PLANNING REPORT

Architectural Review Board

Wednesday, June 28, 2023

112 S. RIVERVIEW STREET 23-021MPR

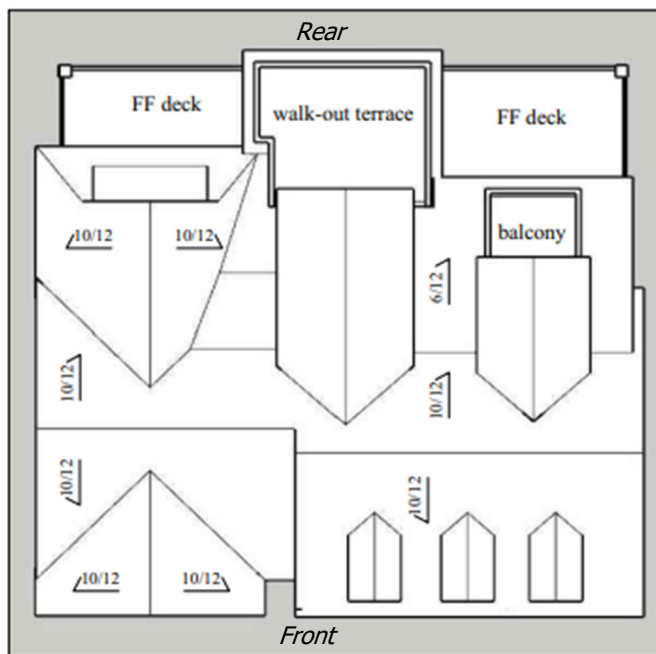
The Cape-Cod style home is proposed with a two-story mass in front and three-story mass at the rear. The proposed structure is now approximately 18 feet 8 inches tall in the front, from grade to the center of the gable, and 32 feet 5 inches tall at the rear. The height of the home from the rear elevation exceeds the height requirement of 24 feet maximum. A Waiver is required from the ARB to permit the proposed height at the rear of the home, enclosed herein.

PDL has provided suggestions to modify the massing of the building to align more with the recommendations of the *Historic Design Guidelines*. PDL still recommends reducing the size of the garage to a 2-car garage rather than a 4-car garage, further simplifying the rear roofline to create a cohesive structure. Staff concurs with this recommendation.
